Re: N6 Galway Ring Road Project
Reference PL07.302848

McCarthy Keville O'Sullivan Ltd ('MKO') have been instructed by their Client, Galway Property Management to prepare a submission to the consultation on the N6 Galway Ring Road planning application (ref: PL07.302848) which is currently with An Bord Pleanála ('the Board') for determination.

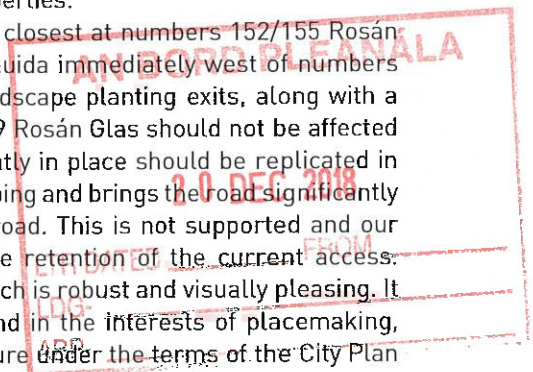
Air quality monitoring was also carried out, with one monitoring location at the northern end of Bun a'Chnoic (R19). Further investigation is required, however it could be questioned as to why there was not one closer to the BD/Rahoon Road interchange.
